***MODIFICATION REQUEST:  
Sydney University Abercrombie  
Precinct Redevelopment  
Cnr Codrington Street and Abercrombie  
Street  
(MP07\_0158 MOD 3)***

- Modification to the Student Accommodation Building

Director-General's  
Environmental Assessment Report  
Section 75W of the  
*Environmental Planning and Assessment Act*  
1979

February 2014

**Figure 5: Proposed Ground Floor Layout (approved outline shown in red)**

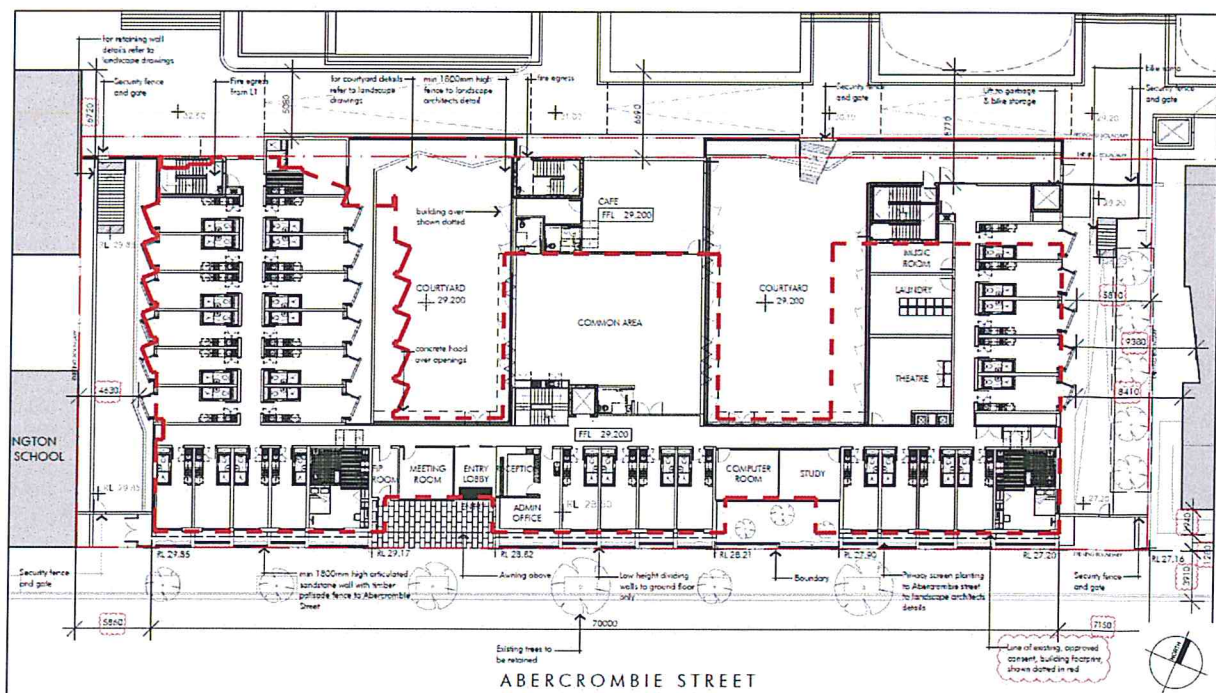
Having regard to the concerns raised within the public submissions regarding amended setbacks, it is noted that the proposal remains consistent with the existing approval and no changes are proposed in this regard. As demonstrated by **Figure 5**, the building setback along the Abercrombie Street frontage and western and eastern elevations is not proposed to be reduced. Further, the side setback from Mandelbaum House is more than adequate to ensure that existing residential amenity is maintained, being 5.8 m to the common boundary, and from 8.4 m to 9.3 m between built forms.

Figure 8: Proposed Eastern Elevation (approved outline shown in red)

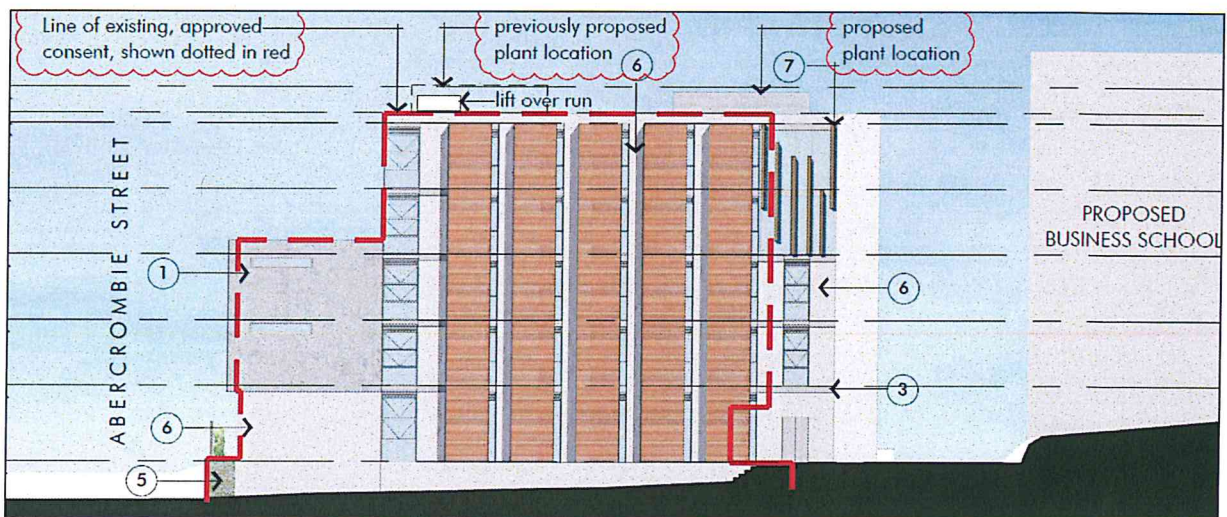
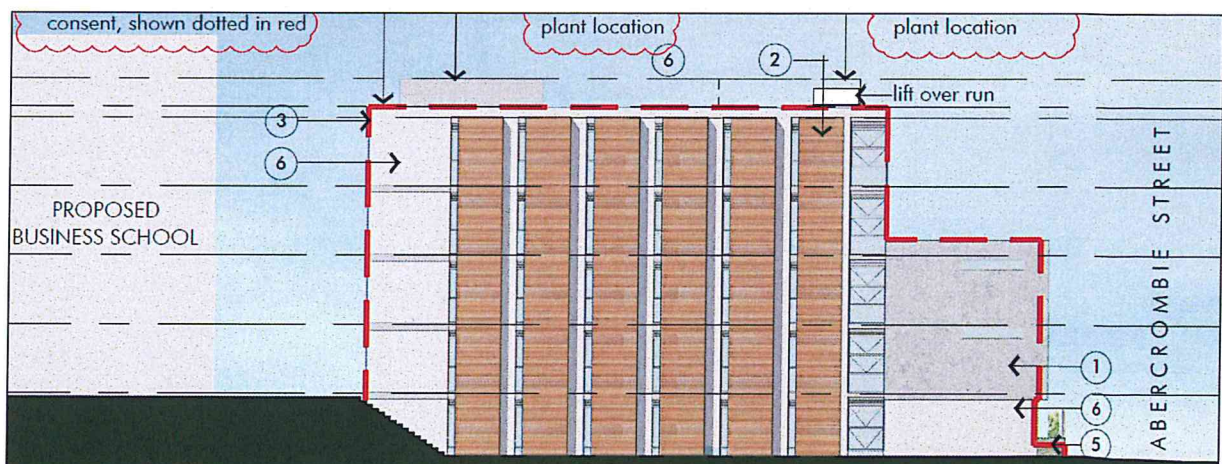
Council further noted that the lower front portions of the eastern and western elevations of the student accommodation building should be clad in a more suitable material, such as sandstone rather than the exposed concrete finish (labelled '6' on **Figures 8 and 9**). In response, the proponent advised that the use of the concrete panelling along these elevations was selected to provide a contemporary design response to the extensive use of sandstone materials on heritage buildings throughout the University's campus.

The department considers that the treatment of the lower portions of the western and eastern elevations provides a satisfactory design response to the setting, noting that the proponent proposes the use of sandstone within the design of the proposed front fencing for the college. It is also noted that these areas are adjacent to proposed pedestrian pathways, which will be landscaped on both sides (see **Figure 11**). This will assist in softening the contemporary concrete finish of these elements of the building.

**Figure 11: Proposed Landscape Plan**

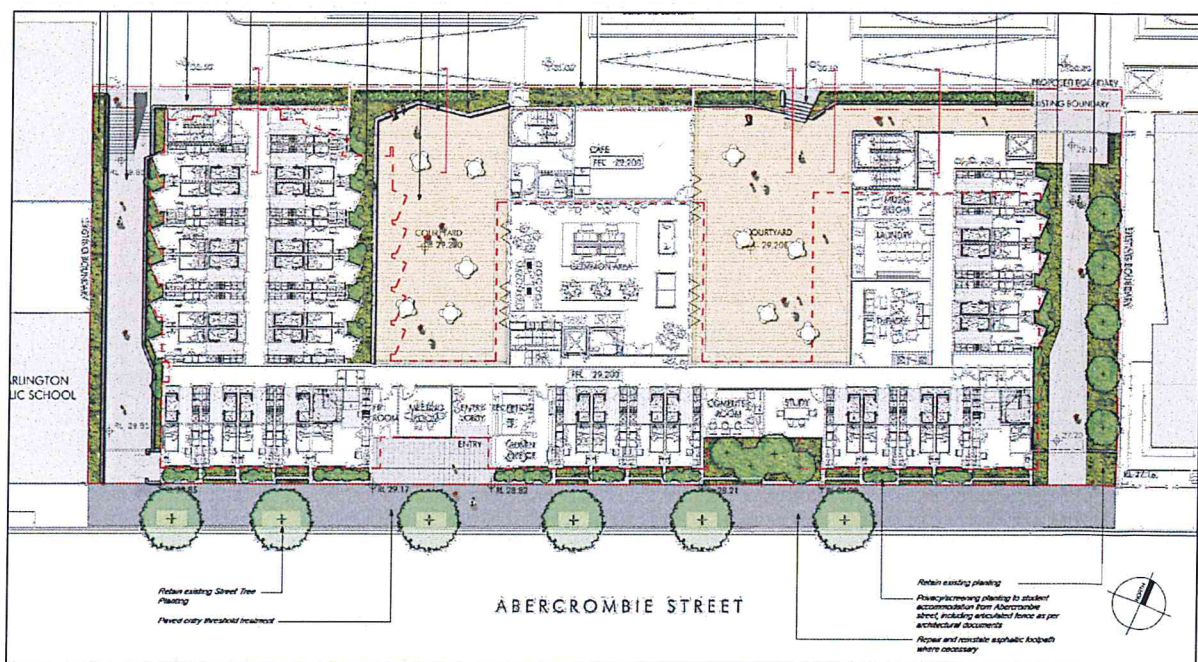
The proponent seeks to amend the landscaping scheme for the student accommodation building in conjunction with the proposed building amendments (see **Figure 11**), including changes to accommodate the relocation of basement entrance access from Abercrombie Street.

The proposed landscaping design details the existing Abercrombie Street vegetation and existing trees bordering the subject site and Mandelbaum House as being retained. The retention of the vegetation and removal of the basement entrance adjacent to Mandelbaum House will assist in retaining the existing amenity enjoyed by its occupants.

The proposed amended courtyard designs, in conjunction with the proposed relocation of the café from the eastern wing to the central wing, will provide a more active and usable space. The large courtyard areas are also provided with direct access from the centrally located common room, with a secondary rear pedestrian access gate provided to offer residents with direct access to and interaction with the University's campus. The proposed courtyard design amendments are considered satisfactory.

**Figure 12: Proposed Fencing – Section Details**

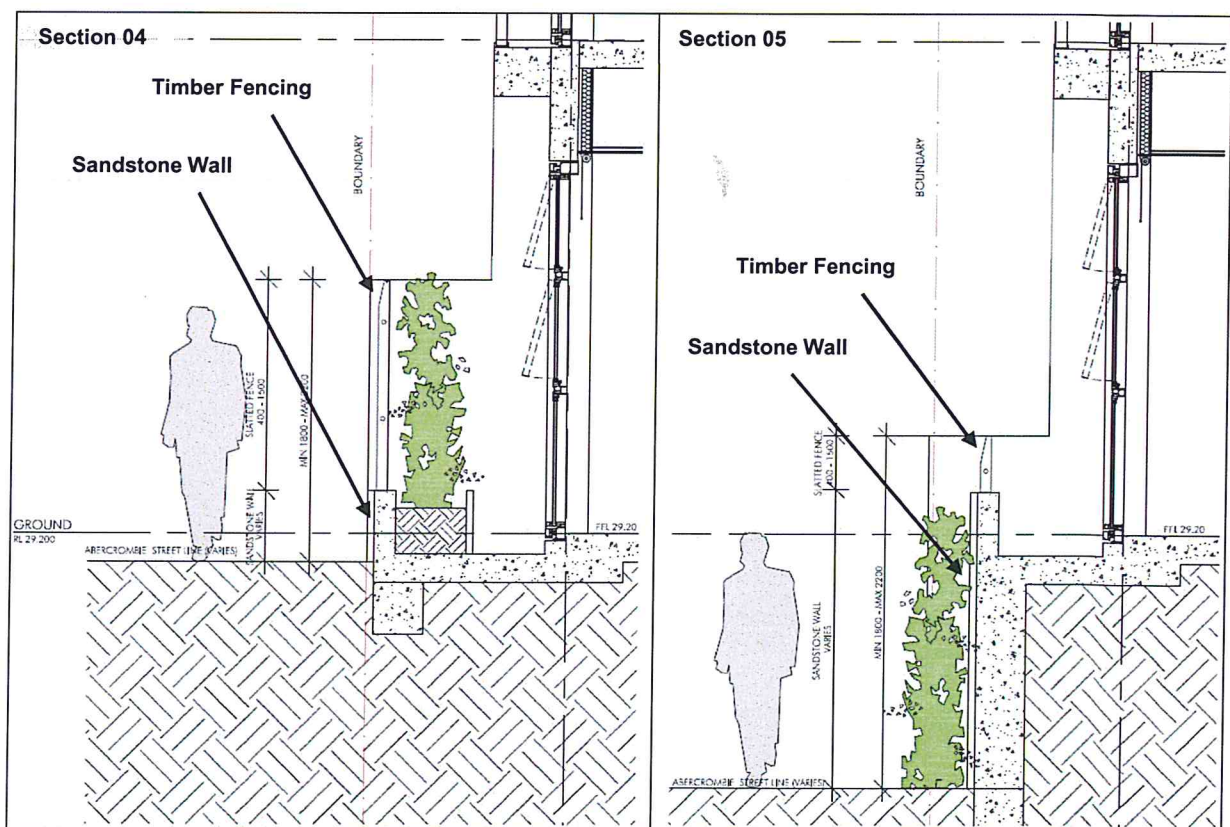
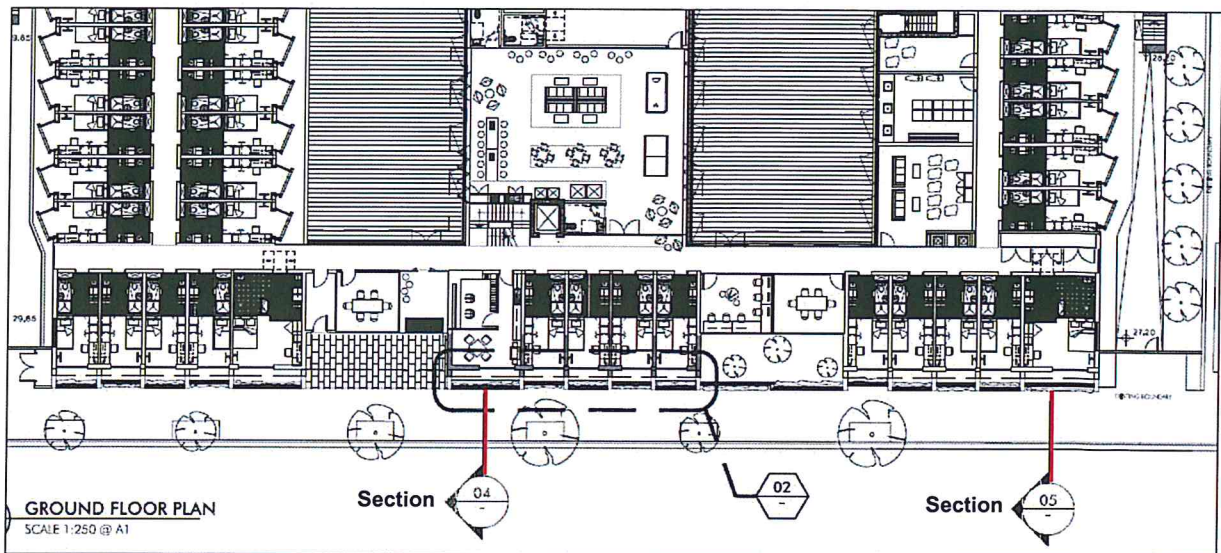
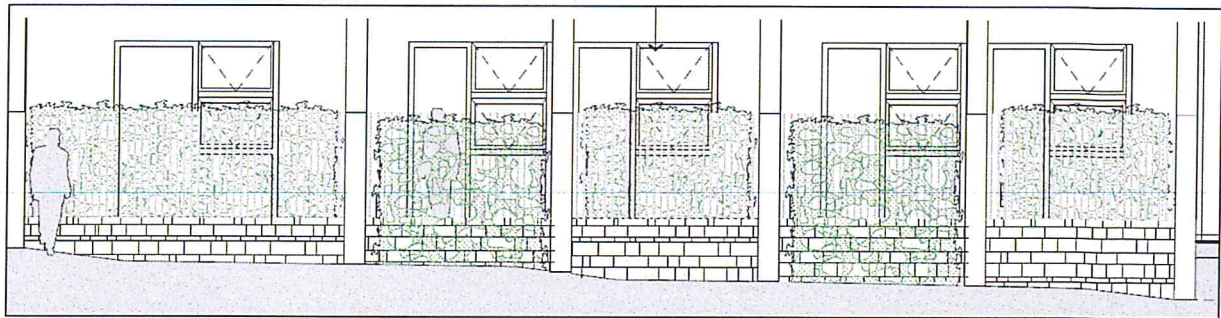
Proposed front fencing details indicate timber batten and sandstone wall fencing ranging in height between 1.8 m to 2.2 m. As detailed in Section 04 of **Figure 12**, the top level of the timber battens remains constant, while Section 05 details the height of the sandstone wall increasing to compensate for the site's approximate 1.8 m downward slope along the Abercrombie Street frontage (see **Figure 12** and **13**). Vegetation is also proposed with the timber batten fencing in an alternating pattern (see **Figure 14**) to break up the fencing line and add variety to the frontage.

While council advised that the timber batten and sandstone wall fencing arrangement provides an improved relationship to Abercrombie Street, it also noted that the relationship between the building, fencing, walls and landscaping created an inactive frontage and reduced passive surveillance opportunities. Concern was also raised with respect to the maintenance of the proposed vegetation integrated into the fencing due to limited access.

In response, the proponent notes that the fencing has been provided to create a residential character along the site's frontage, whilst still permitting visual permeability. The department considers the proposed fencing along the site's frontage to be satisfactory in providing security for the occupants of the development. It also offers a design response that reflects the non-institutional character of the local area. With respect to council's concerns regarding the lack of passive surveillance, the department notes that single bed studios are proposed predominantly along the ground floor, to which a level of vegetation and screening for privacy should ideally be provided. Notwithstanding, the permeable nature of the proposed fencing will ensure passive surveillance is possible when the rooms are occupied. Further, Levels 1 and 2 will also have single studios fronting Abercrombie Street, which will also provide casual surveillance to enhance the sense of safety and security.

The proponent also maintains that vegetation can be satisfactorily established within the proposed fencing planter beds and that once established, minimal maintenance is anticipated. However, the department considers that appropriate measures should be in place to ensure that the vegetation is satisfactorily established and maintained. Accordingly, the department recommends a new condition be imposed on the project approval, requiring the proponent to provide details to the satisfaction of the certifying authority demonstrating that landscaped areas for the college can be satisfactorily accessed to ensure their ongoing management and maintenance.
